Access Compliance Report

Public Rights-of-Way

(Pedestrian Signals)

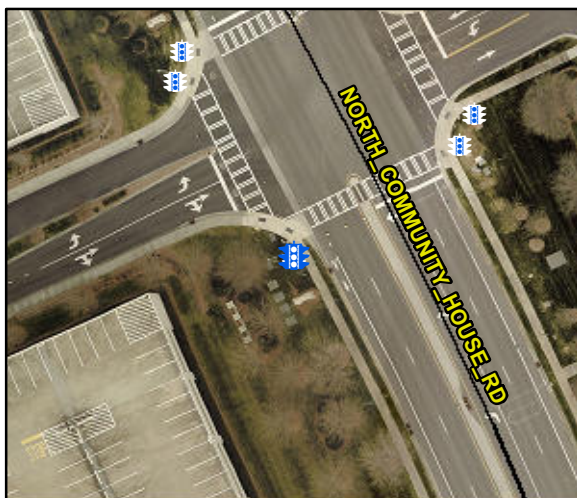
Intersection ID: N/A	Main Street:	Cross Street: N/A	Location: N/A
ADA ID: A4D72D6492DB	Signal Type: One Push Button-Non APS	Overall Compliance: No	Severity Score: BTN 1: N/A BTN 2: N/A No BTN: N/A
Codes/Mitigation Info/Possible Solution		Field Measurements/Component Compliance

PROW/ADA: TMUTCD 4e.08, R404.2, R404.3

Possible Solutions: Replace Signal Push Button With APS Button on New Post. Remove & Relocate Sign.
